Product Change Notice (PCN)

Ref no: 3009052

Concerning Part Name: PISM

Product Type: Power Inductor

Description of Change:

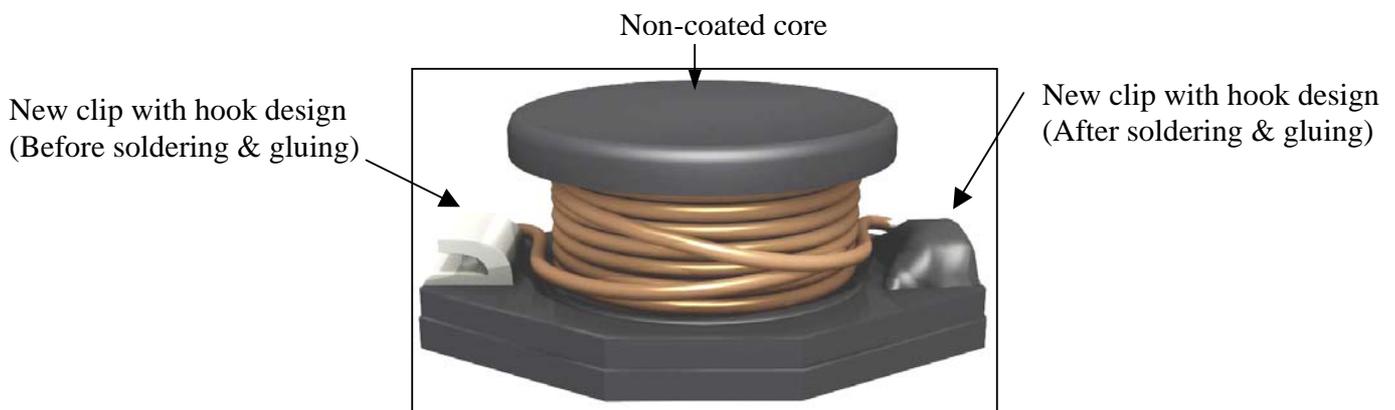
Transition Version --> new clip and base (refer to picture)

REASON for clip: To improve the wire termination robustness and to introduce lead free solder

REASON for base: To match the new clip design

Complete Version --> new ferrite core, non-coated (refer to picture)

REASON: To improve marking permanency and adhesive strength between core and base.

Expected Influence: All electrical parameters remain as per FASTRON specification, however sample testing for approval is recommended only for the complete version.
